ADDENDUM NO. 1

TERRY CARGIL RESERVOIR

LACEY CONTRACT NO. PW 2019-32

C-8

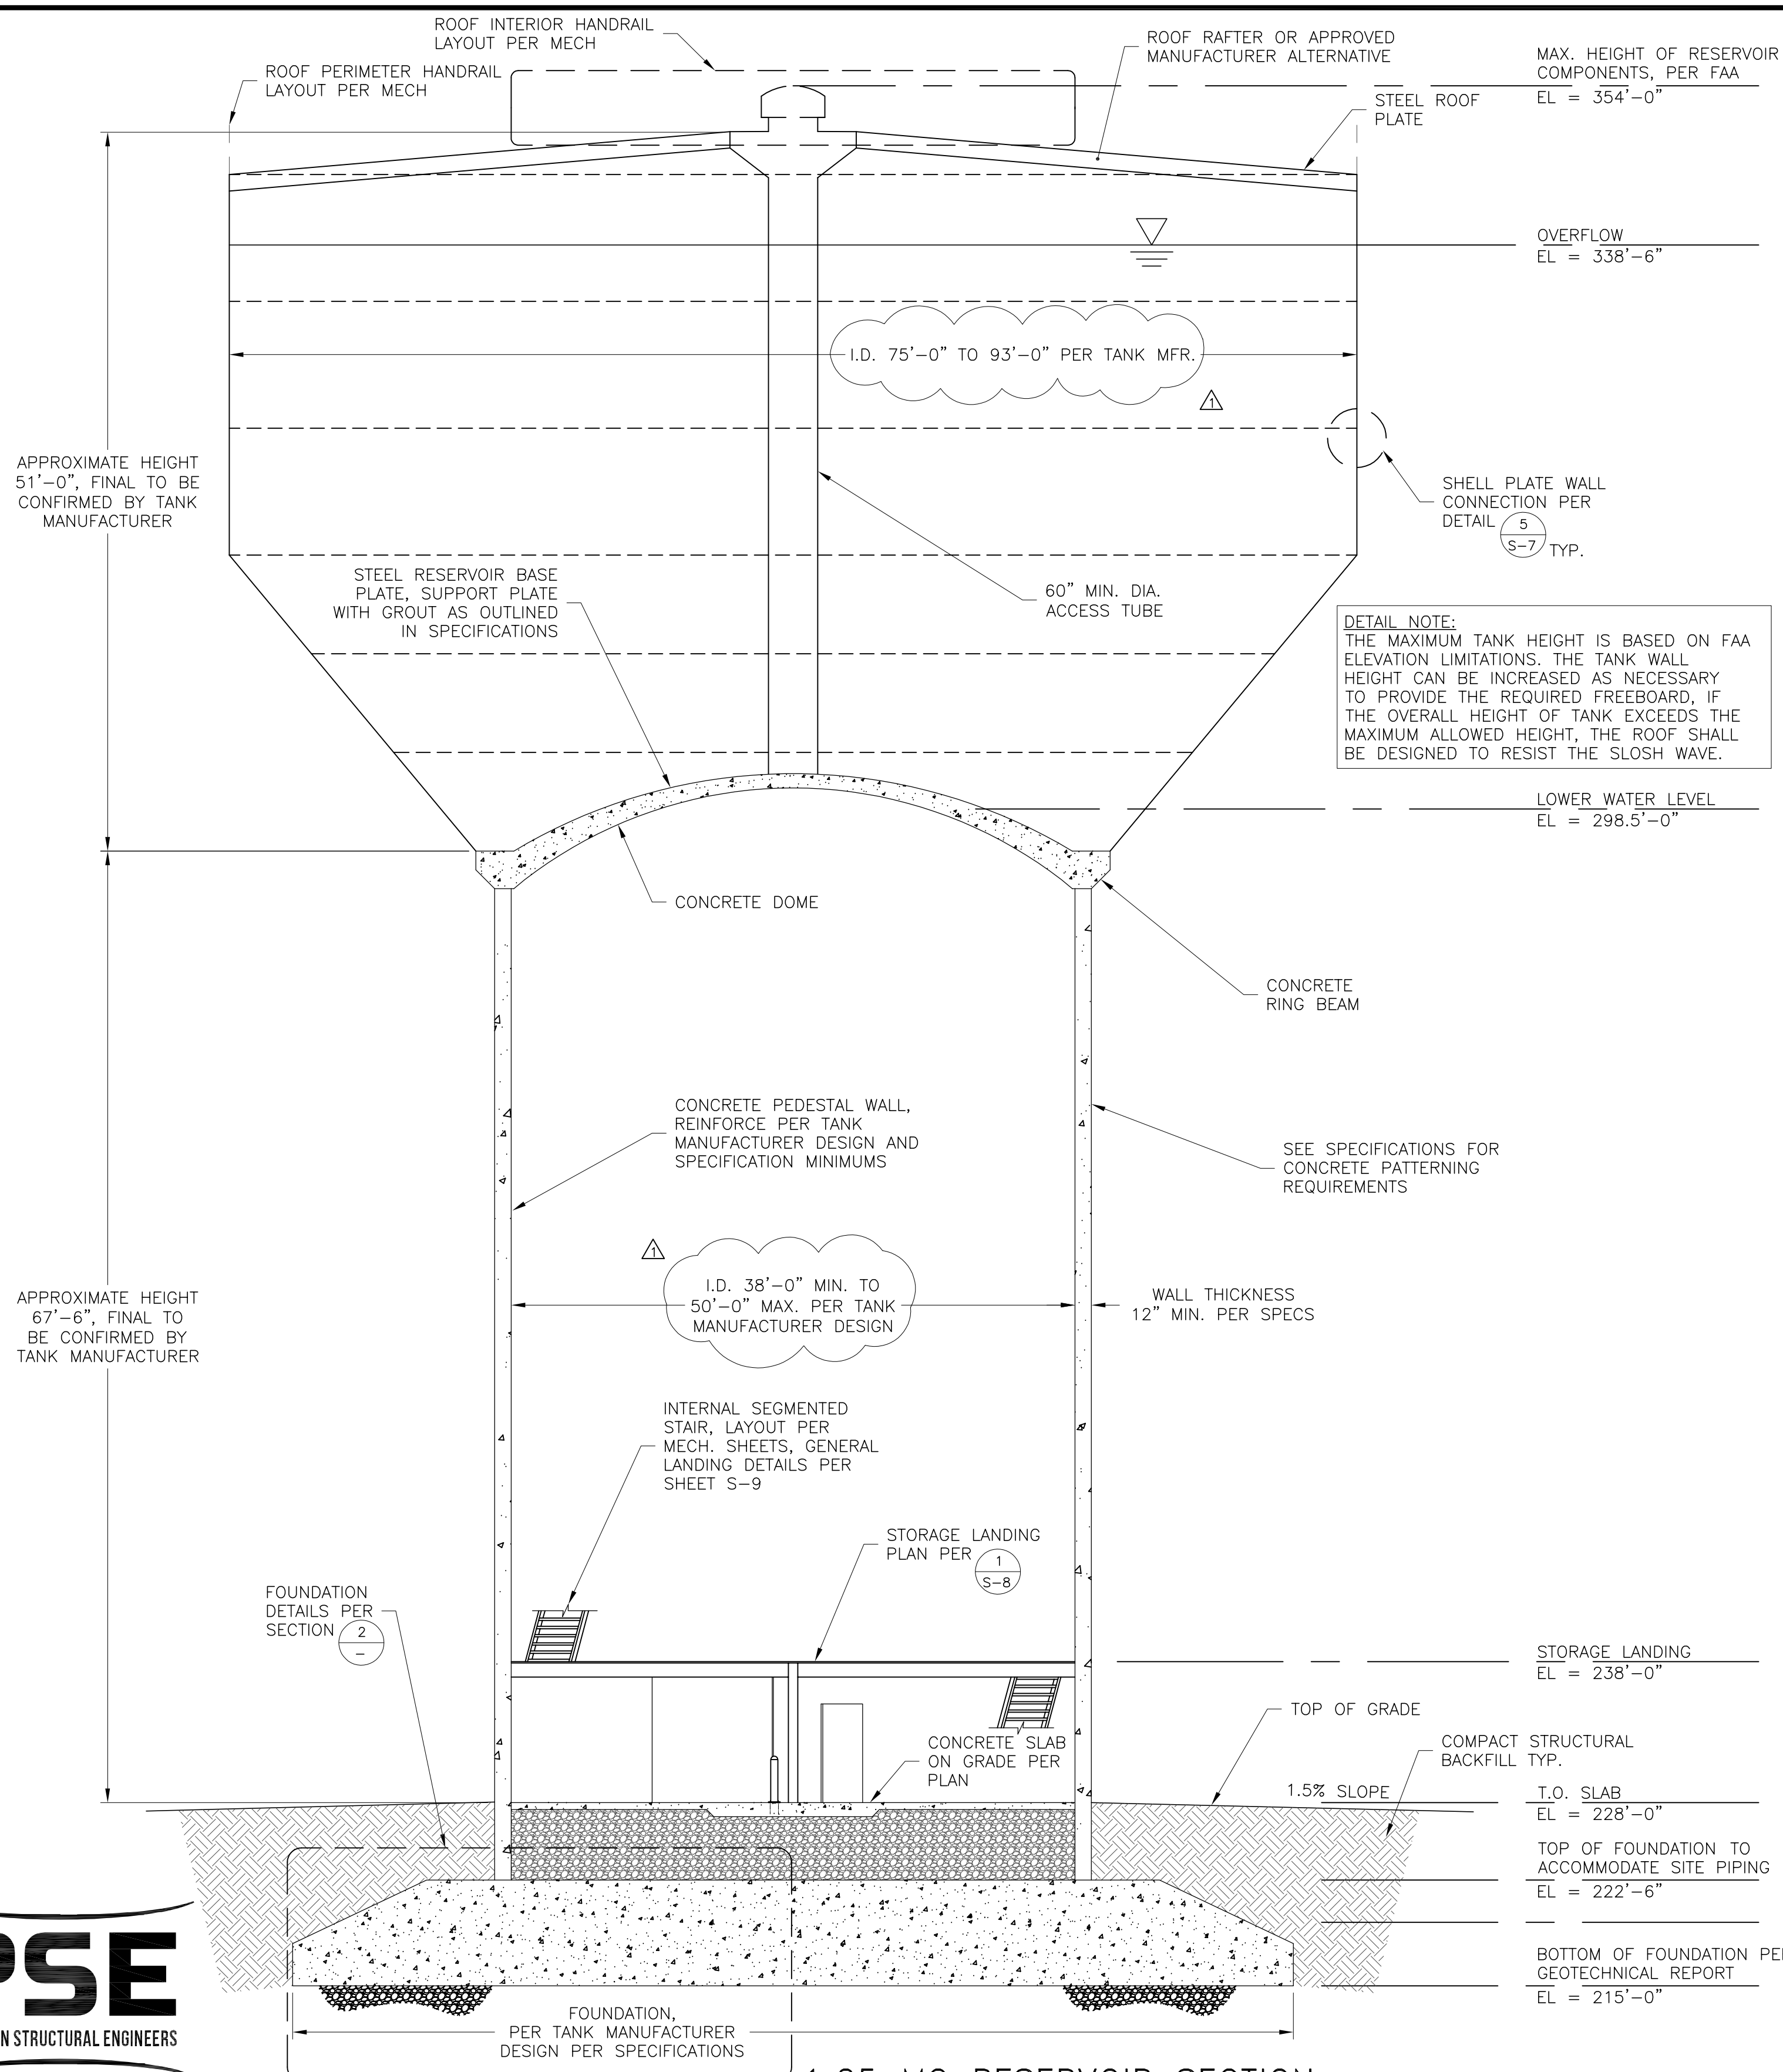
- 1) *The revisions include changes to notes related to the reservoir diameters.*
Delete Sheet C-4 / Page 13 of 62 and replace it with the new page as attached.

75' - 93' RESERVOIR INSIDE DIAMETER, PER TANK MFR

40' - 52' RESERVOIR OUTSIDE DIAMETER, PER TANK MFR

SHEET
S-3
22 of 62

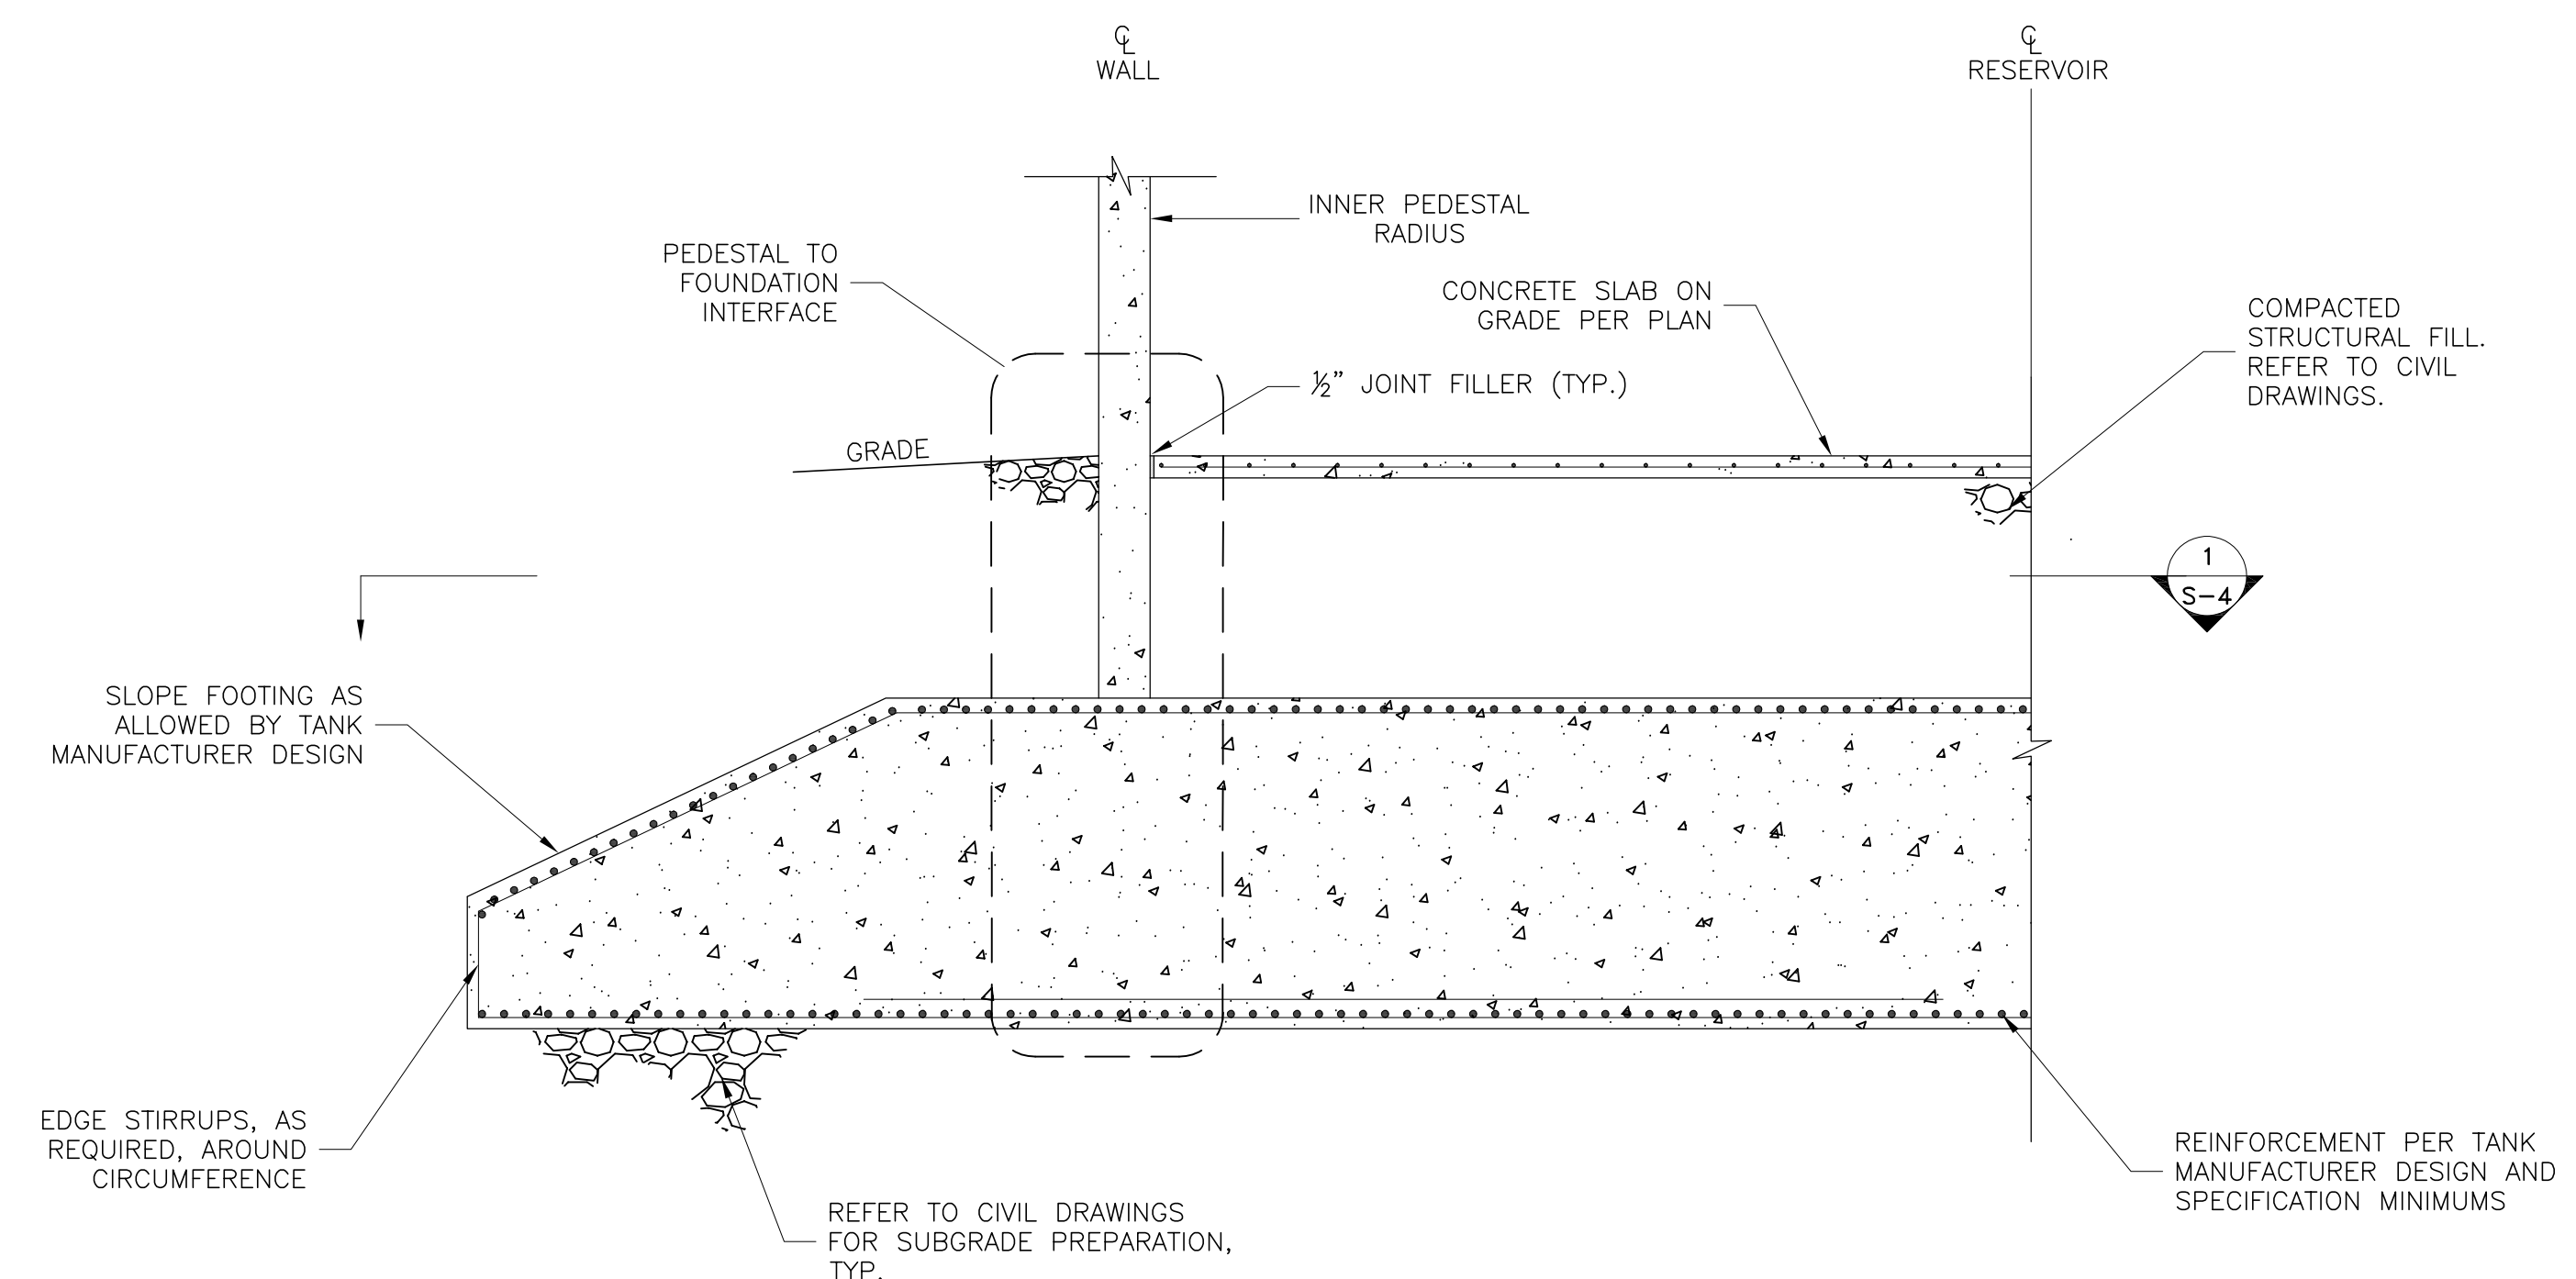
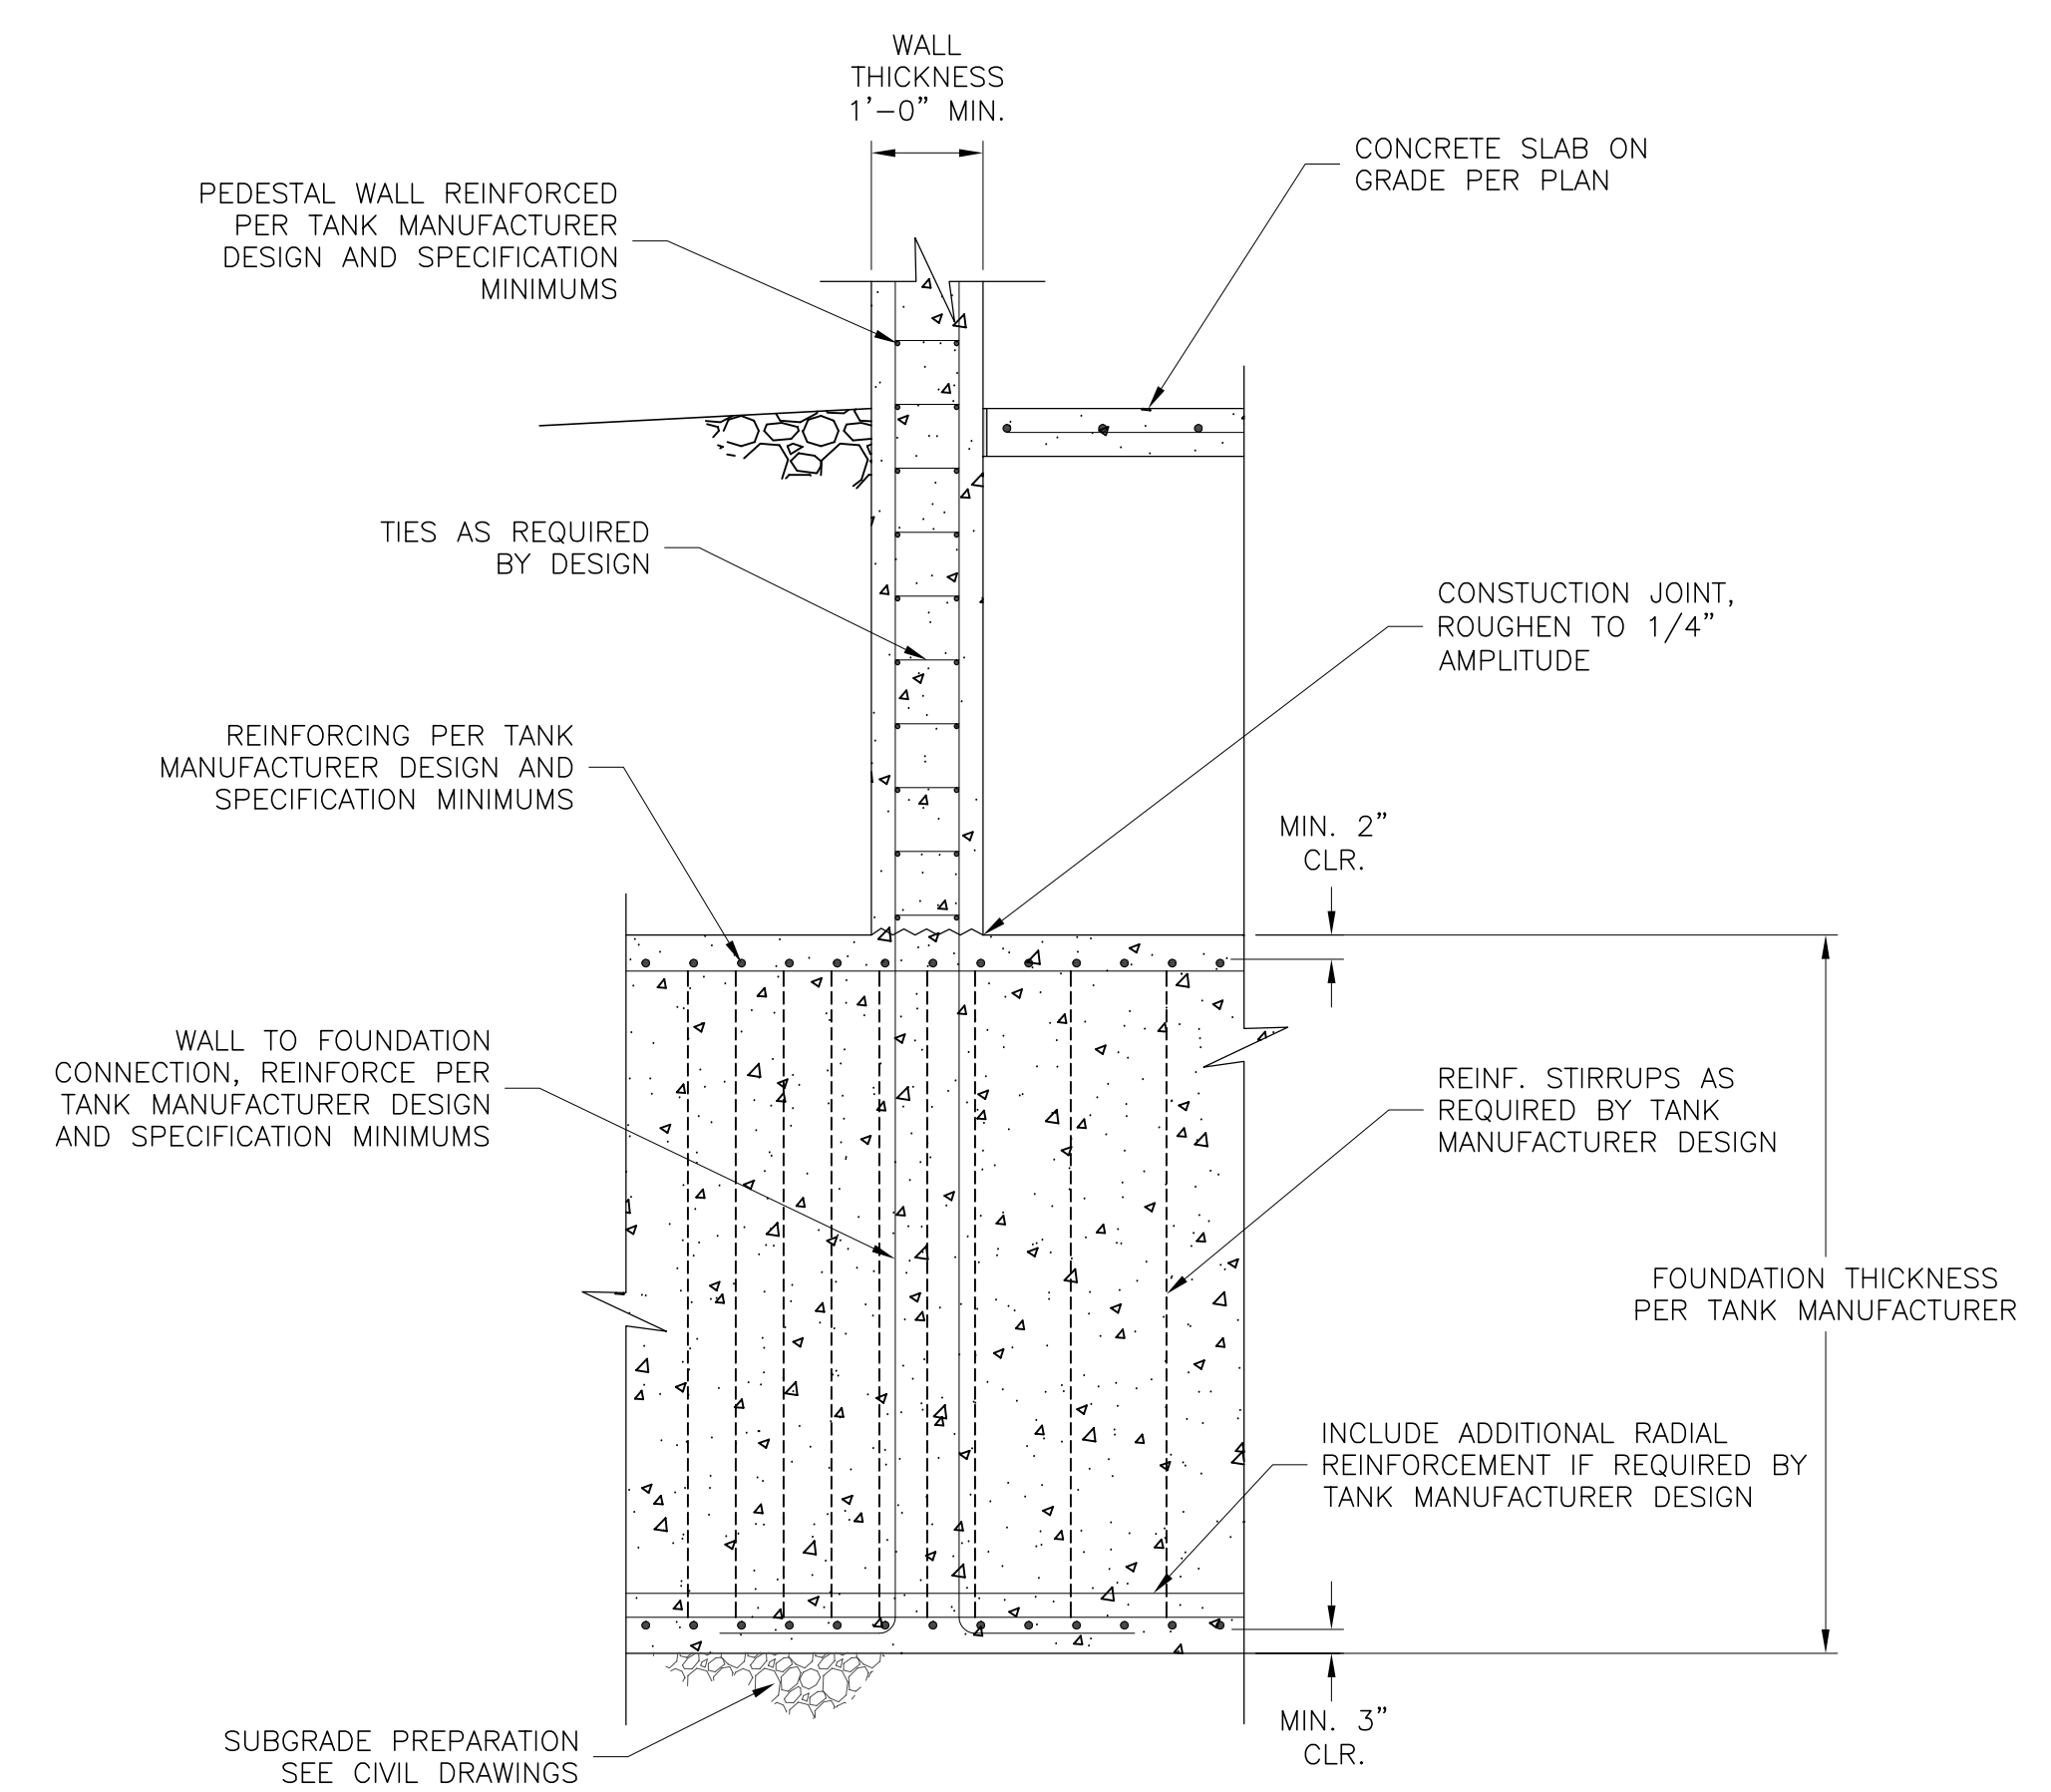
- 1) *The revisions include changes to notes related to the reservoir diameters.*
Delete Sheet S-3 / Page 23 of 62 and replace it with the new page as attached.

1. PRELIMINARY DESIGN FOR BIDDING PURPOSES.
CONTRACTOR TO PROVIDE FINAL DESIGN OF COMPOSITE
ELEVATED TANK AND FOUNDATION.
-  2. THE CONTRACTOR SHALL COORDINATE ALL DESIGN
ASPECTS WITH THE FINAL PROPOSED BASE COLUMN AND
RESERVOIR DIAMETER FOR A FULLY INTEGRATED DESIGN.
